INTRODUCTION

This errata provides information applicable to the following products:

- 1-002-0017 programming adapter Rev.B or earlier

These changes allow you to work with secured ARM MCU via JTAG interface

STEP1

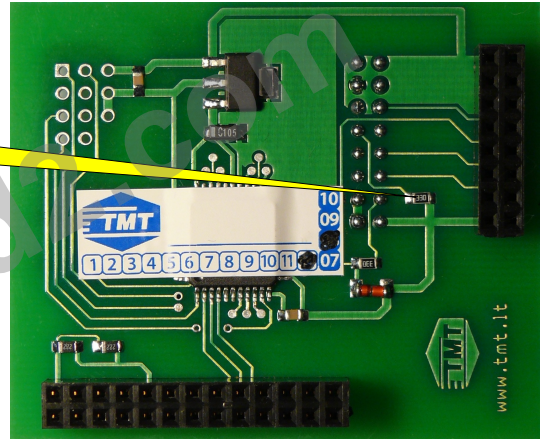
Remove this resistor

STEP2

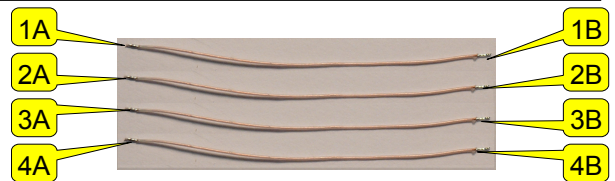
- Prepare the four wires. About 5cm in length.

STEP3

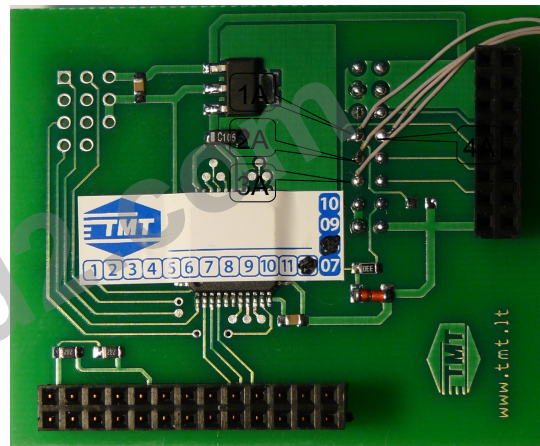
- Solder wire shown in the corresponding points at the bottom side
